COTTONWOOD GROVE 3RD ADDITION

Re: S/D 98-3 -- Final Plat of COTTONWOOD GROVE 3RD ADDITION

STAFF REPORT

CASE NUMBER: S/D 98-3 - COTTONWOOD GROVE 3RD ADDITION

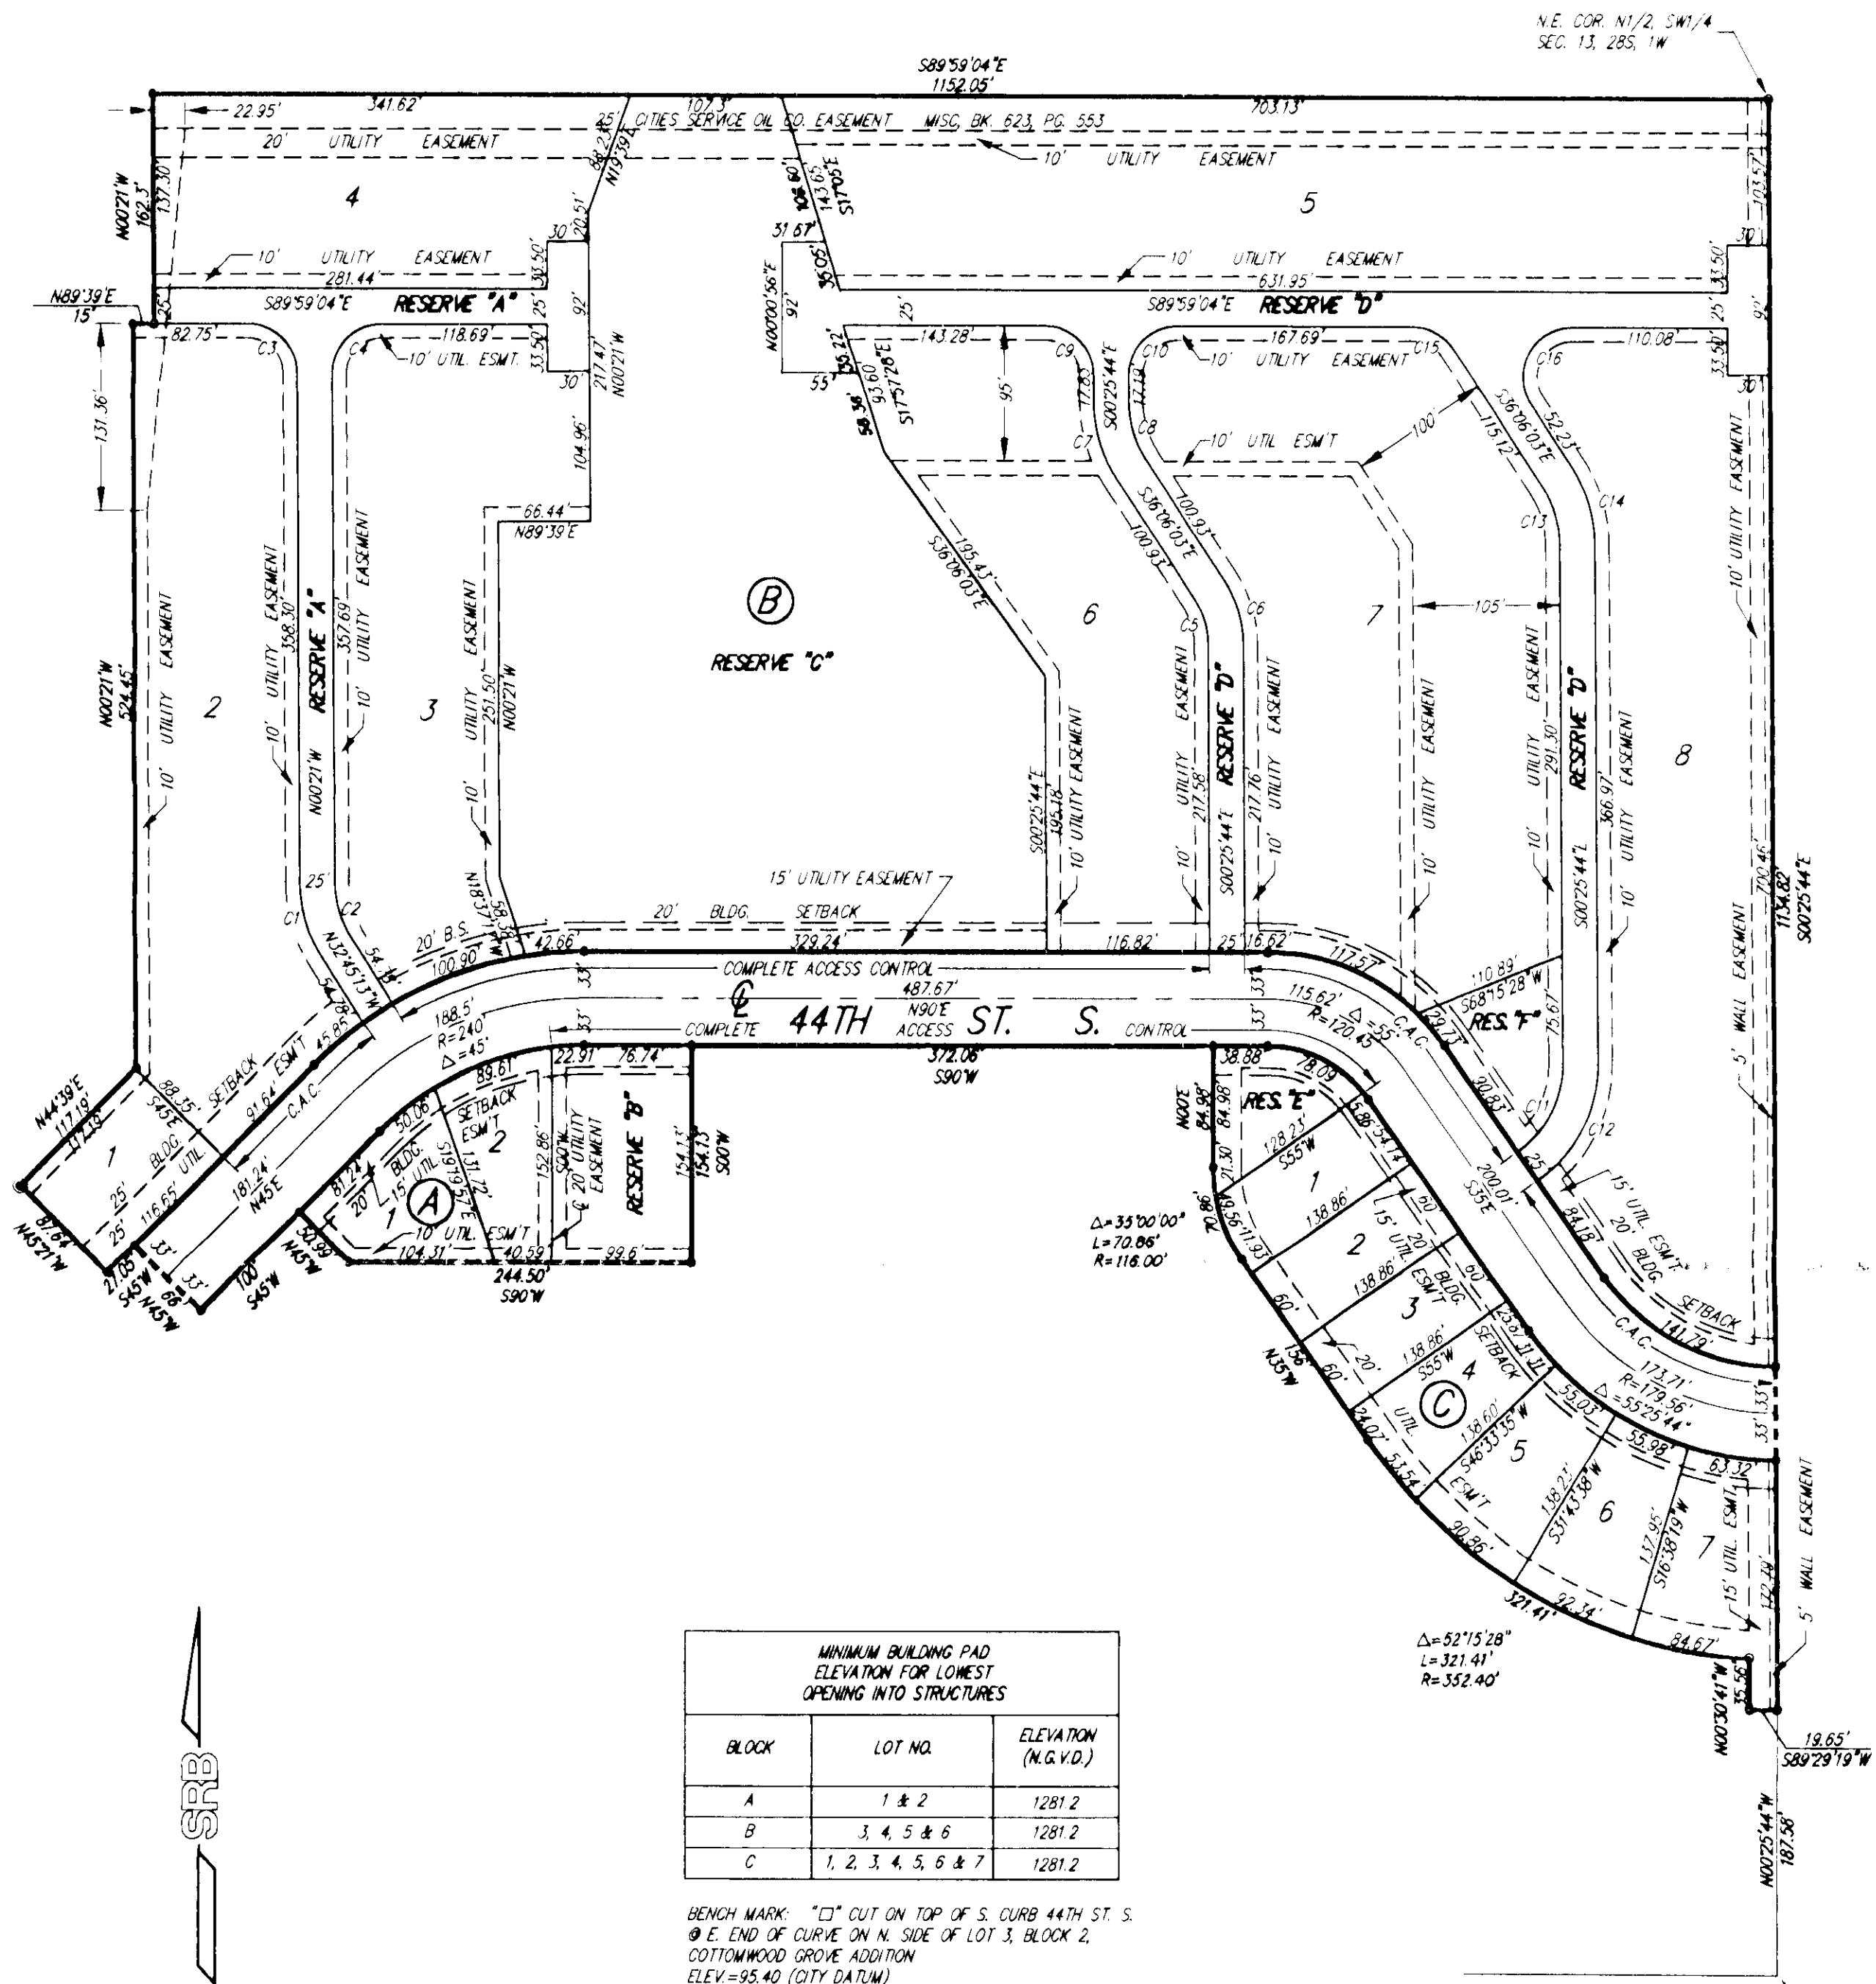
- A. The applicant needs to guarantee the extension of City water and sanitary sewer to serve the lots being platted. City Engineering needs to comment on the need for any additional guarantees for municipal services. City Engineering requests a sanitary sewer layout to determine location of easements.
- B. If improvements are guaranteed by petition, a notarized certificate listing the petitions shall be submitted to the Planning department for recording.
- C. City Engineering needs to comment on the status of the applicant's drainage plan. The drainage plan is approved. A guarantee will be required and minimum pads need to be platted for the lots adjacent to the lakes.
- D. Complete access control shall be dedicated along 44th Street South except at the location of the private street reserves and except along the single-family lots.

The final plat indicates the requested access controls. The final tracing needs to denote access controls along the south side of 44th St. South.

- H. A covenant shall be submitted regarding Reserves A and D, platted for private drive purposes, which sets forth ownership and maintenance of the private drive, and future reversionary rights of the reserve to the lots benefiting from the reserve. The plat's text shall reference the platting of the reserve for private drive purposes and shall state which specific lots are to be accessed by the reserve.

- I. The applicant shall also guarantee the paving of 44th Street South to collector street standards, including sidewalks on both sides.
- J. The final plat shall indicate temporary turnarounds at the terminus of the private streets at the east and west line of the plat, and adjoining Reserve C. A "T"-type turnaround may be provided as an alternative to the standard circular turnaround for the terminus of the private streets adjoining Reserve C. Dedication of the temporary easements by separate instrument shall be provided.

- K. Fire Department needs to comment on the acceptability of the private street access. Fire Department requests a temporary cul-de-sac at the terminus of 44th St. South along the east line of the plat.

- M. The applicant's agent shall determine any setback requirements for the pipeline by researching the text of the pipeline agreement. If a setback from the pipeline easement is provided for in the pipeline easement agreement, it shall be indicated on the face of the plat.

- W. The applicant is reminded that in accordance with the Protective Overlay, a landscape buffer is required along the north and east lines of the plat along with a landscaped street yard in accordance with the City Landscape Ordinance.
